# Input Data

## Plan Amendment

## SR 201 Connection

Figure 1: Added lanes between version 8.3 and 8.3.1.

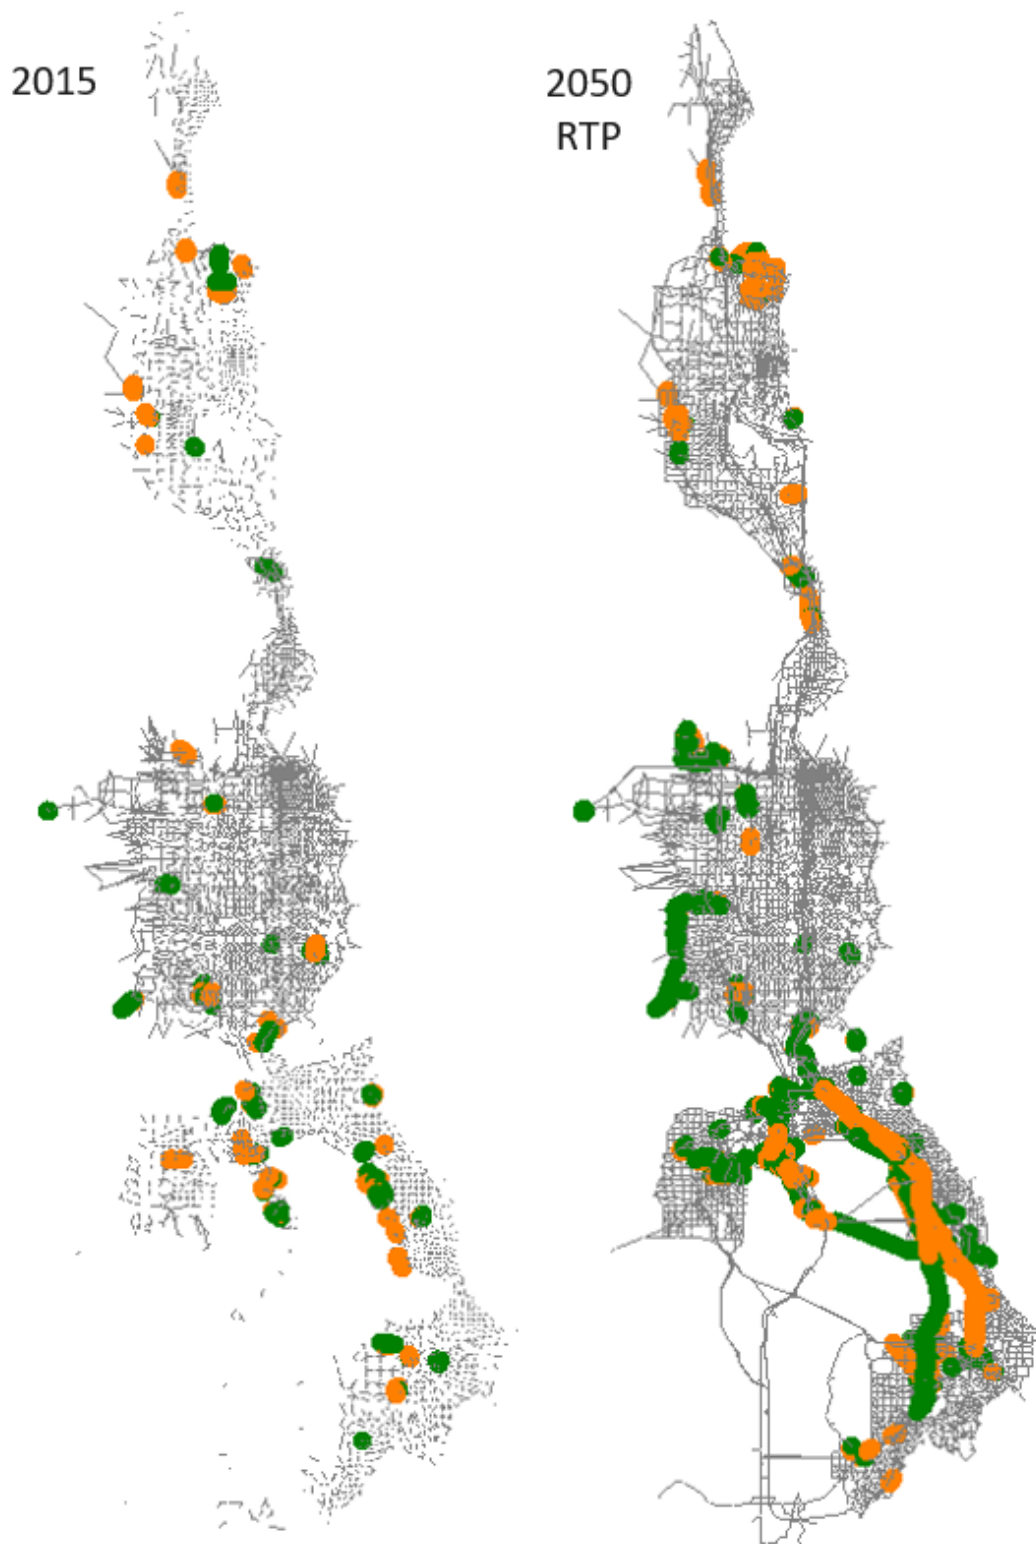
The highway network was updated in the MAG and WFRC areas to reflect the first round of Regional Transportation Plan (RTP) amendments. Additional edits were made in the MAG area to conform with more recent project clarification. The changes to the input highway network are significant, particularly in Utah County, and would most likely affect the travel model's output. Projects in and around areas of high change may want to do sensitivity tests to better understand the impact that these input network changes may have had on project-level decisions. Figure [1](#) shows where lanes were added (green) or were taken away (orange) between versions 8.3 and 8.3.1 highway networks.

Figure 1: SR 201 connection externals.

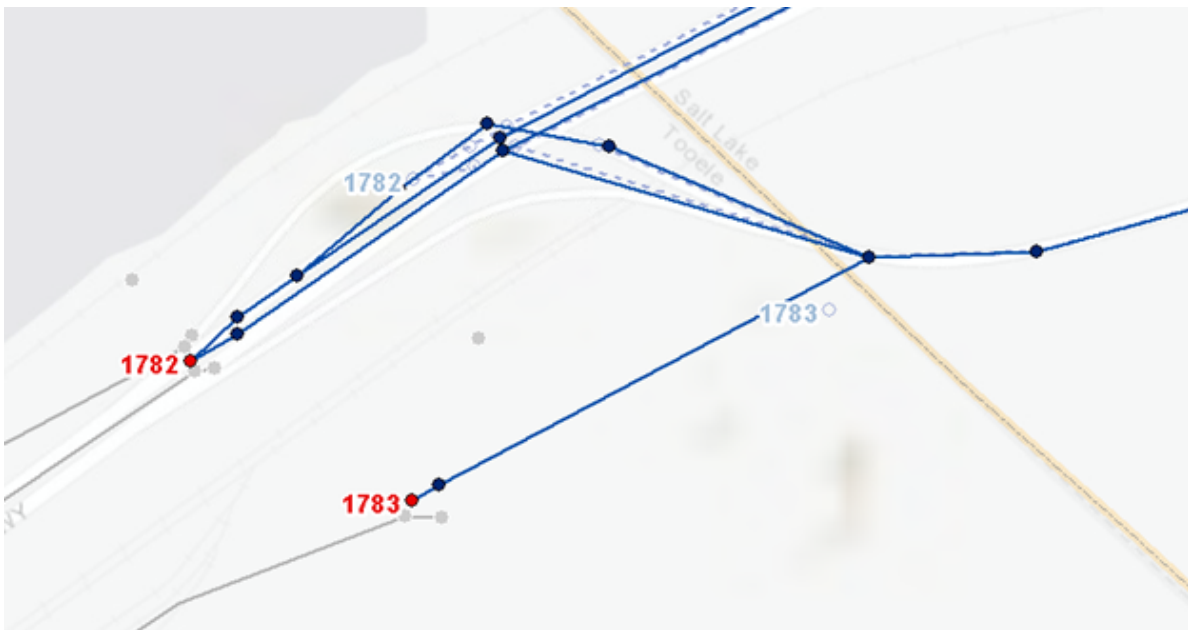
The highway network was modified at the Salt Lake, Tooele County boundary to provide an independent connection to SR 201 at external 1783. (Note external 1783 existed in the version 8.3 network as a place holder and was not connected to the network in that version.) Externals 1782 and 1783 were moved to improve the connection between the Wasatch Front and USTM travel models. The connecting highway links were also modified to accommodate this change.

External 1783 is connected to the highway network via a high-speed divided highway (FT=14) beginning in the 2030 fiscally-constrained plan year. In this year, external volume forecasts also begin for external 1783. Prior to 2030, external 1783 is unconnected to the scenario network and the external volume is zero.

Figure 2: Average weekday traffic volumes for externals 1782 and 1783.

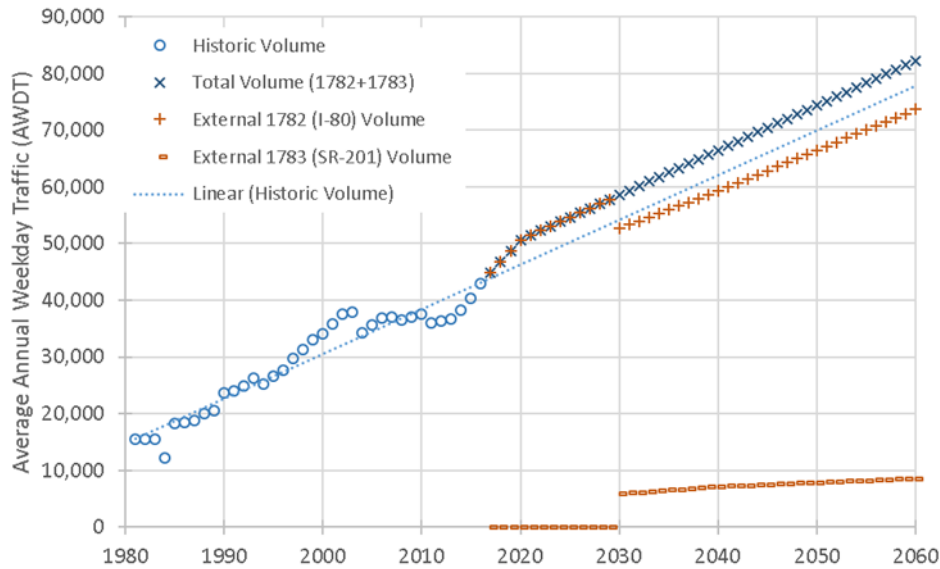
8.3 volume was then divided between the two externals based on information from the Utah Statewide Travel Model (USTM) and professional judgement. The average weekday, single-unit and combo-unit factors for external 1782 were brought up to date with the most current information from the master segment shapefile in the model input folder:

- Average Weekday Factor = 1.057 (was 0.980)
- Single-unit Truck Factor = 7.6% (13%)
- Combo-unit Truck Factor = 9.8% (was 10%)

While the forecast AADT is identical to version 8.3, the change in weekday factor increased the input volume into the Wasatch Front model space by roughly 6%. The relative share of these trips also changed with significantly fewer medium trucks and more passenger cars. The share of heavy trucks stayed about the same. The weekday and truck factors for external 1783 were set to be equal to external 1782.
